UNITED STATES DEPARTMENT OF COMMERCE
National Oceanic and Atmospheric Administration
NATIONAL MARINE FISHERIES SERVICE
West Coast Region
7600 Sand Point Way NE, Bldg. 1
Seattle, Washington 98115

Re: Sacramento River Temperature Management Plan

Reclamation's June 27, 2016, Sacramento River Temperature Management Plan

Figure 40. May 16, 2016, Shasta Reservoir Isothermobath

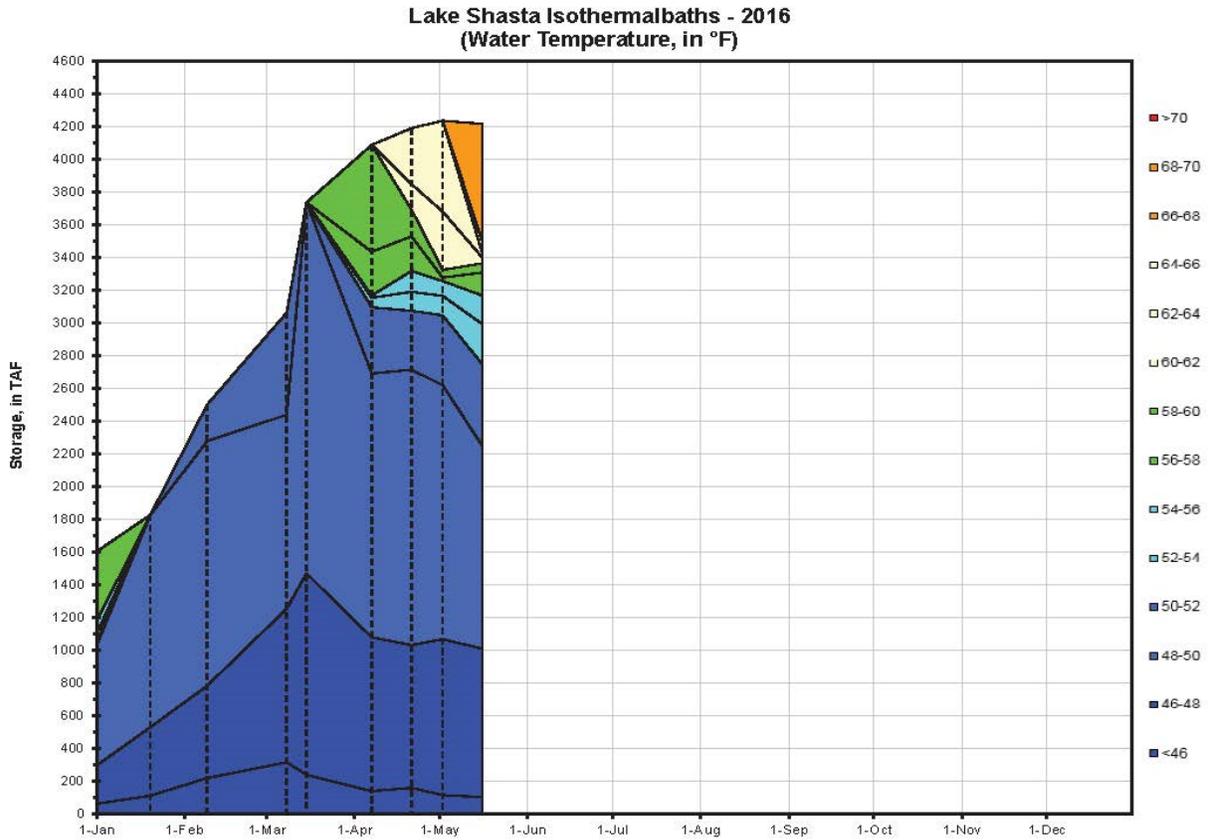
Shasta Reservoir isothermobath profile from May 16 (Figure 40) showed that the volume of 48°F and colder water is stabilizing, indicating the lake has stratified. Reclamation ran the Sacramento River temperature model using the May 90% exceedance hydrology (based on May 1, 2016, hydrologic conditions and forecasted river inflow), with an estimated monthly Keswick release of 9,000 cfs for June and 10,000 cfs in July and August, and 10% L3MTO parameters. Keswick was modeled to target 53°F DAT and included a 1.3°F increase from Keswick to CCR (Figure 41). Results of this run indicated opening of full side gates was delayed to October 14.

Figure 47. May 31, 2016, Keswick release scenarios temperature-dependent survival histogram.

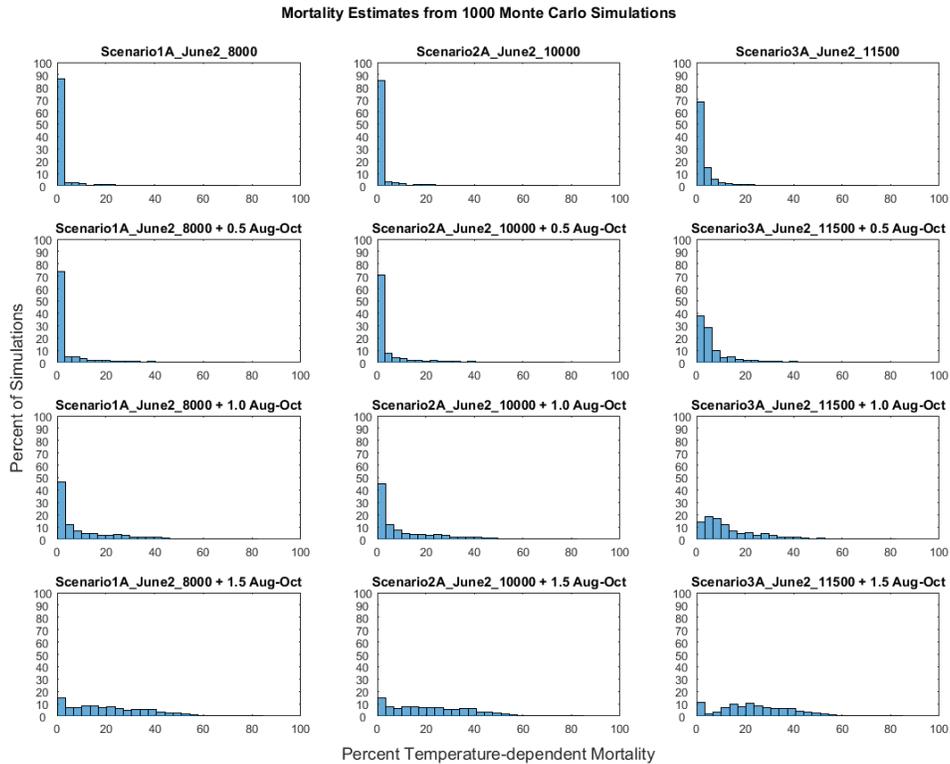
The NMFS-SWFSC plotted the three scenarios with all three levels of exceedance against each other in order to illustrate the tradeoffs with increasing flow (Figures 46 and 47). For example, in Figure 47, second row, if the Keswick release temperatures are off by 0.5°F, there is a ~70% chance of no mortality in the 8,000 and 10,000 cfs runs, but it drops to 40% for the 11,500 cfs scenario. While the 8,000 and 10,000 cfs runs are pretty much indistinguishable, the likelihood of exceedance goes up dramatically under higher flow scenarios. The upper left of the graphs, at stable Keswick release of 8,000 cfs, is most favorable for winter-run Chinook, and most achievable. As stable Keswick release increases, the likelihood of release temperatures increasing through the temperature management season increases as well.

Figure 47 also illustrates the differences in the Keswick release temperatures in August through October and the resulting temperature-dependent mortality. For example, in the first column, the 11,500 cfs runs start showing the effect of late season temp increases; the difference between the 8,000 and 10,000 cfs run are not large enough to be distinguishable in the temperature-dependent mortality model. Then as you move down each row (assuming higher exceedances), the magnitude of the late season effect becomes greater. There is still no difference between the 8,000 cfs and 10,000 cfs runs but, the likelihood of exceedance goes up with increasing flows. Therefore, it would be appropriate to compare the risk of temperature-dependent mortality in one Keswick release scenario with that of another release scenario one row down, that is, with higher likelihood of temperature exceedances.
